Applicant: Susan Faus; City of Edina  
Consultant: Britta Hansen; Emmons and Oliver Resources, Inc.  
Project: Playground  
Location: N.E. corner of Fred Richards Golf Course – Parklawn Avenue and Nine Mile Creek Regional Trail: Edina  
Rule(s): 3,4,5,11 and 12  
Reviewer: BCO

**Permit #:** 2019-63  
**Project Name:** Fred Richards Park Playground; Parklawn Avenue and Nine Mile Creek Regional Trail: Edina  
**Approval Date:** June 19, 2019

**FRED RICHARDS - PHASE 1**  
 CITY OF EDINA / MN

**EROSION CONTROL  
 PLAN**

**C102**

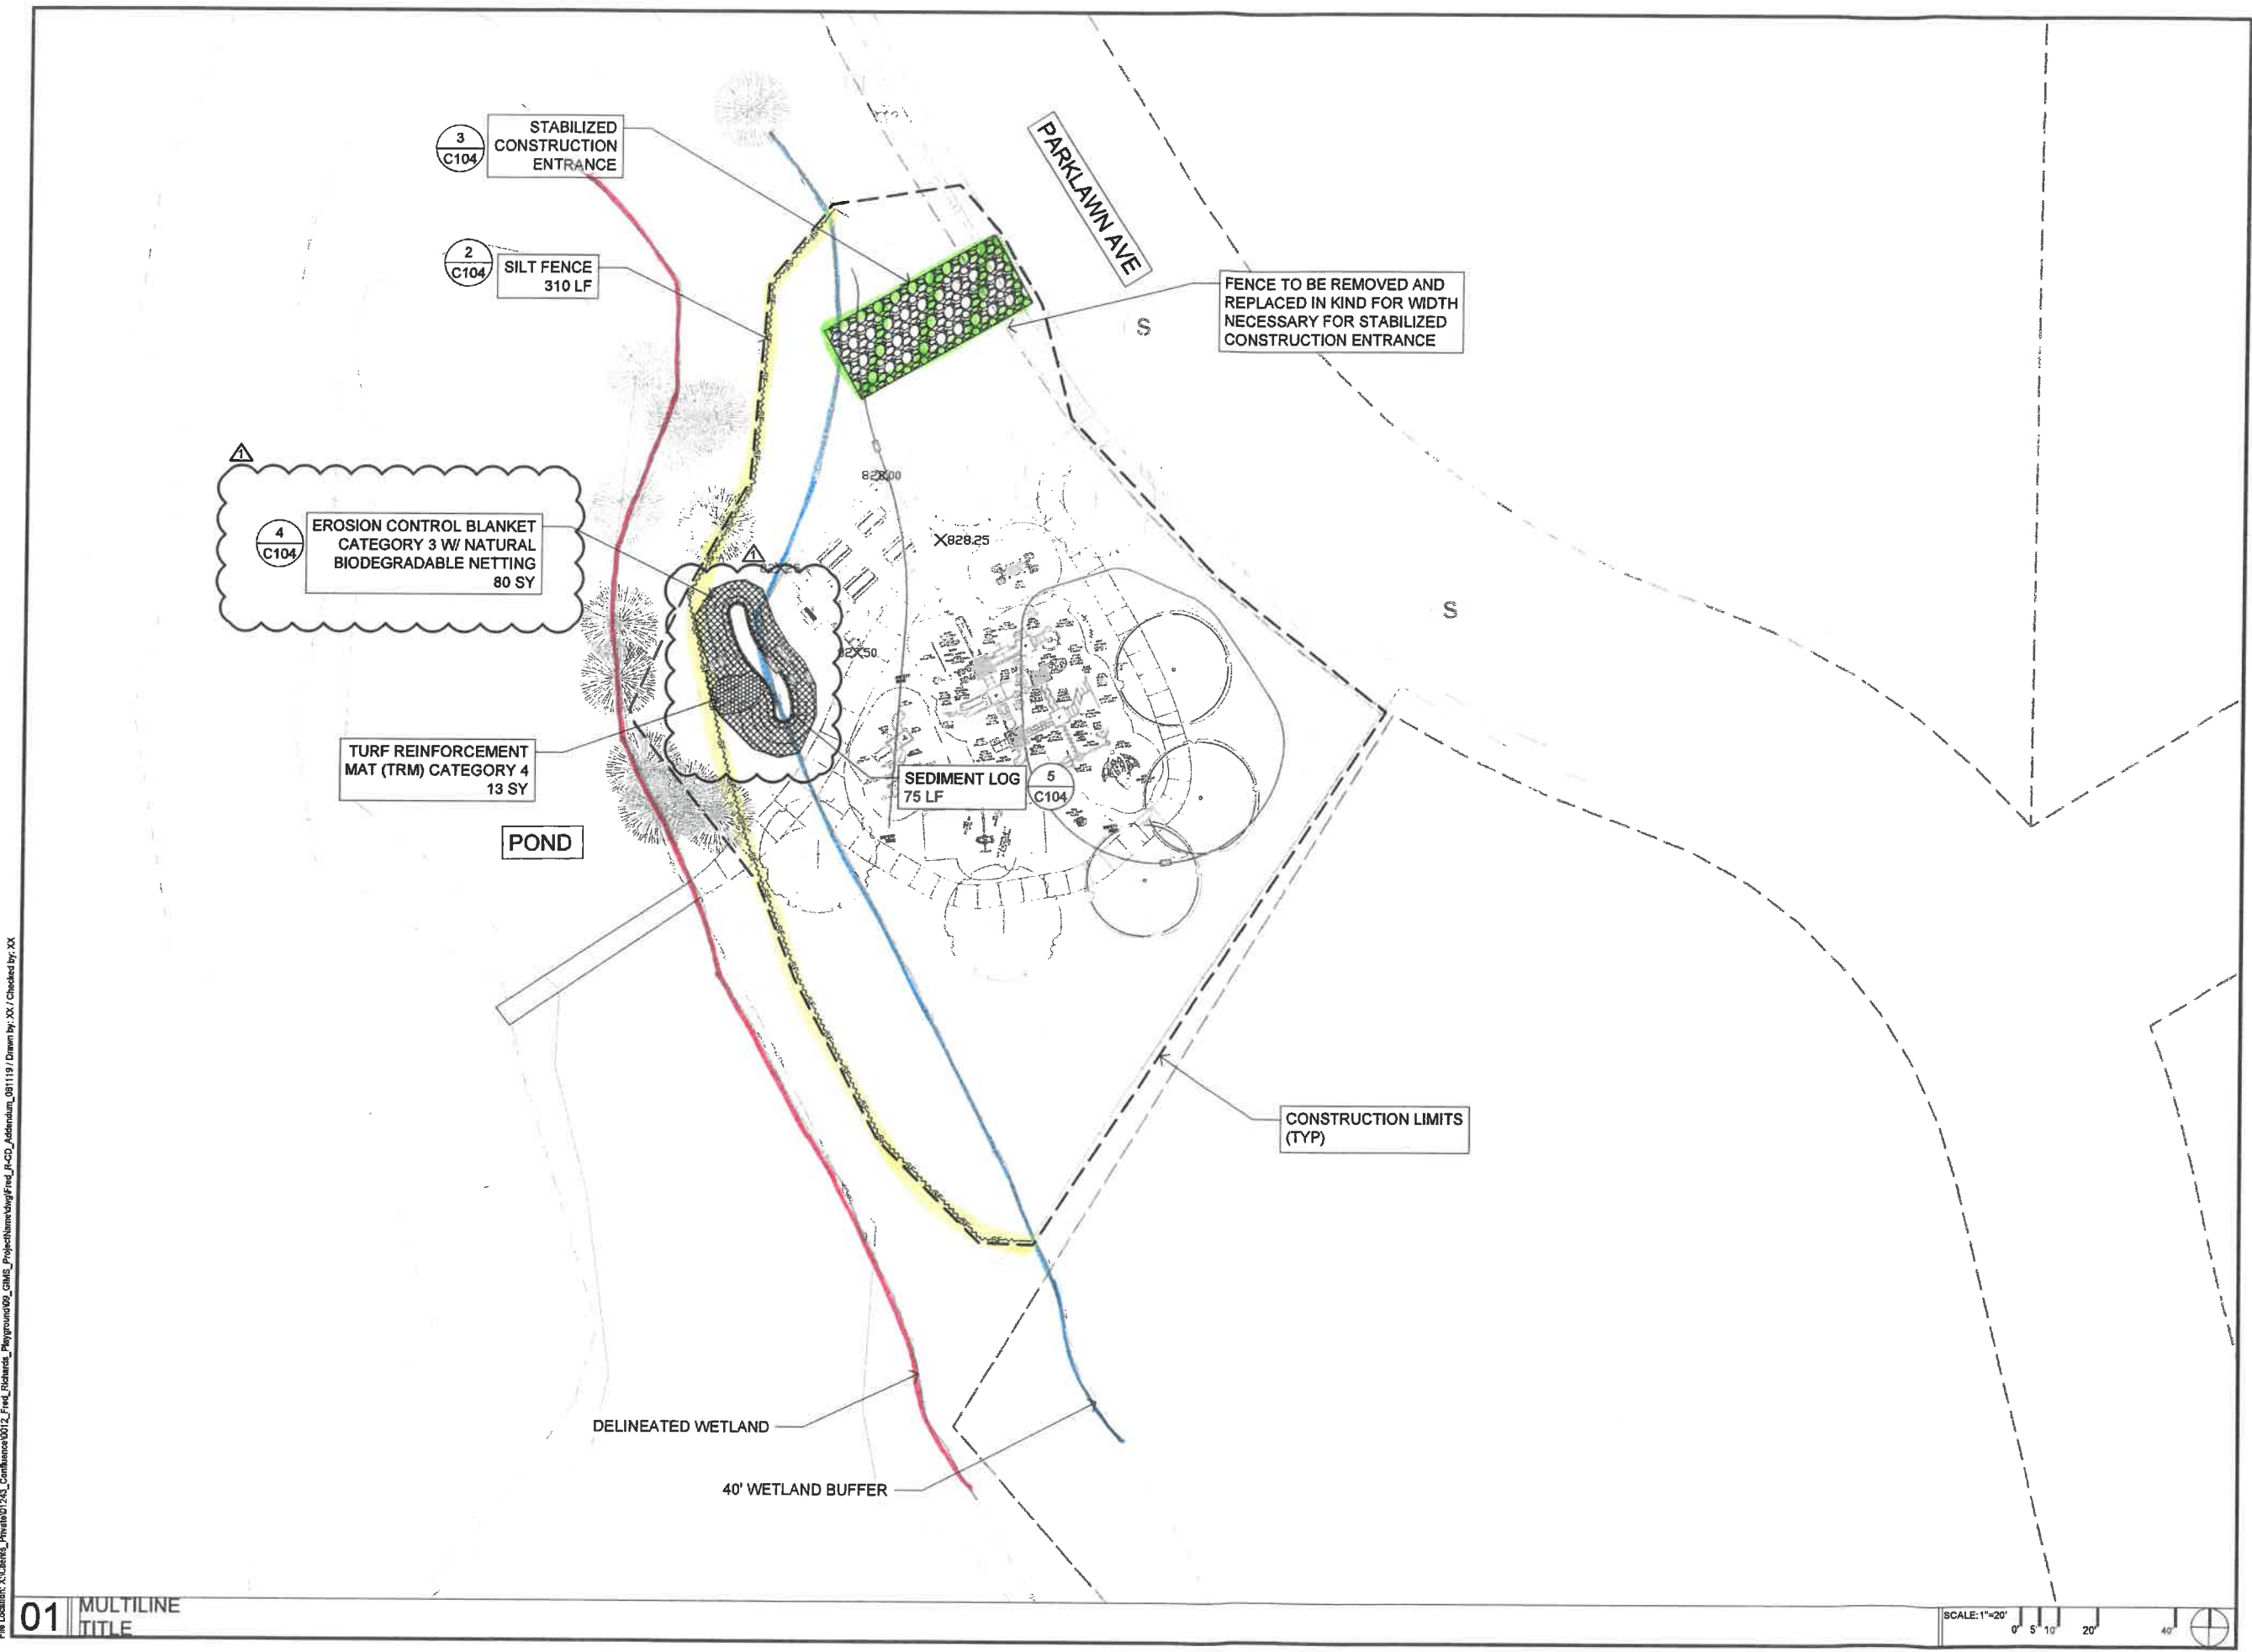
Silt fence, filter logs, and a rock construction entrance are to be installed to provide erosion control.

The submitted erosion and sediment control plan includes silt fence at the limits of construction and a rock construction entrance at the entryway onto the site. The project contact is Britta Hansen, Emmons and Olivier Resources, Inc.
